Huntington County Community School Corporation Exterior Building Maintenance (Various Buildings)

Project # 2025.0016

ADDENDUM NO. A-2

DETAIL 14 SERVICE YARD FOUNDATION WALL

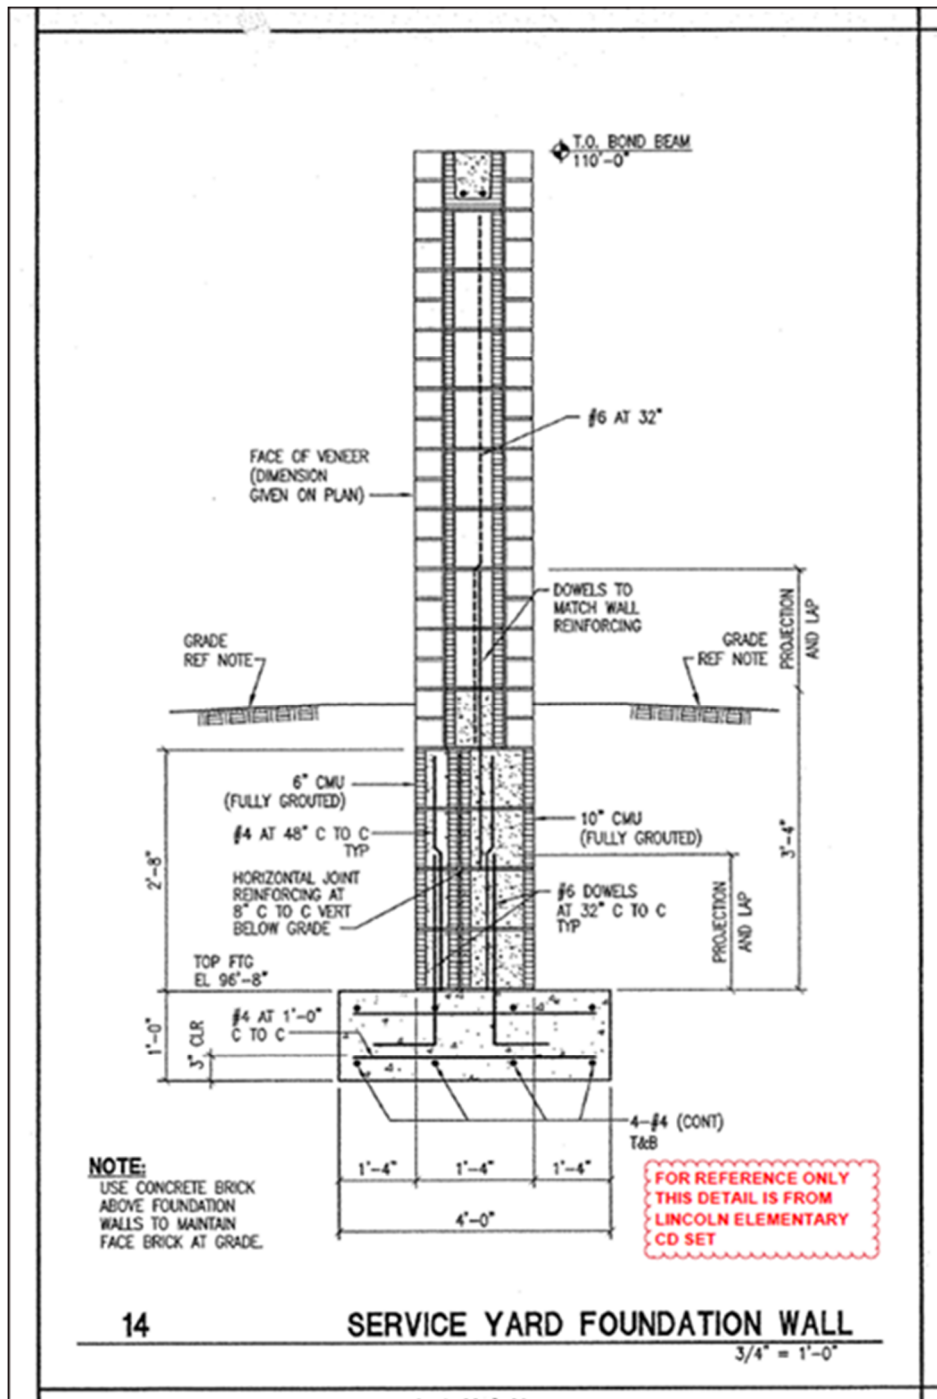
Item: A-2.3
Location: General
Description: **Helical Pier Flint Springs (only) Do you have a geotechnical report, core samples, etc.?**
Is there a pile placement plan with loading per pile?

CLARIFICATION - We do not have any other information on the location.

See [ADDENDUM #2] EXHIBIT #1 - DETAIL 14 SERVICE YARD FOUNDATION WALL at Lincoln Elementary. The schools are almost identical. Note that we cannot guarantee that the wall is constructed as shown below.

CRESTVIEW C-A1.2 ENLARGED PLAN UNIT 'A'

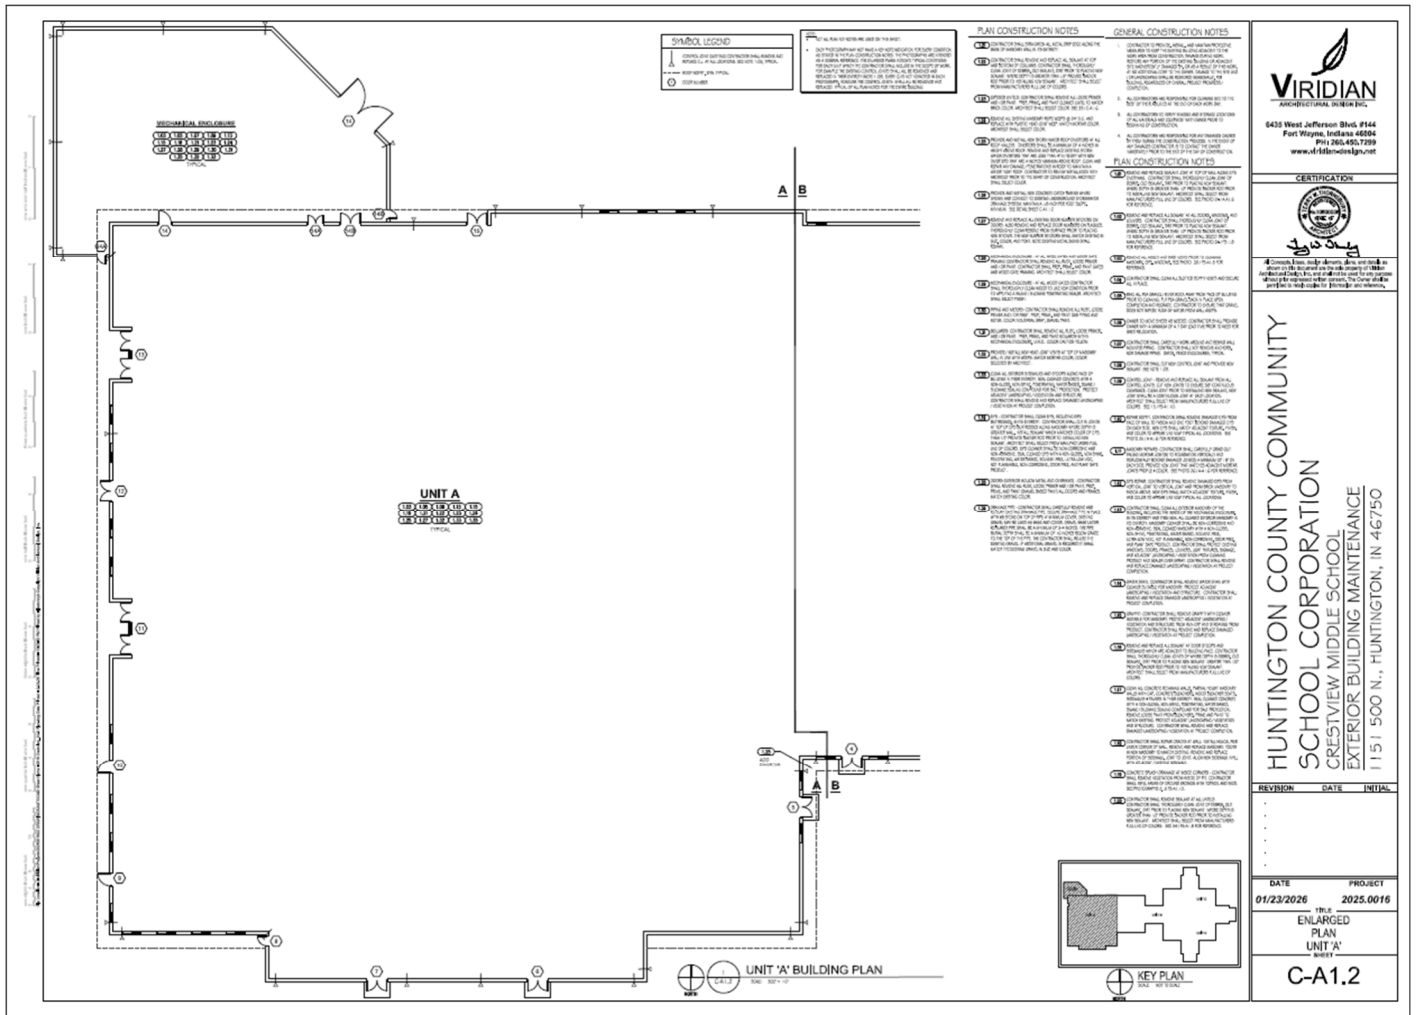
Item: A-2.9
Location: General
Description: **CLARIFICATION - Crestview Middle School – note 1.36 REMOVED from scope of work**
See [ADDENDUM #2] EXHIBIT #2 - REVISED SHEETS:
Crestview C-A1.2 Enlarged Plan Unit 'A'
Crestview C-A1.4 Enlarged Plan Unit 'B'
Crestview C-A1.6 Enlarged Plan Unit 'C'
Crestview C-A1.8 Enlarged Plan Unit 'D'

[ADDENDUM #2] EXHIBIT #2 – REVISED SHEETS to exclude note 1.36
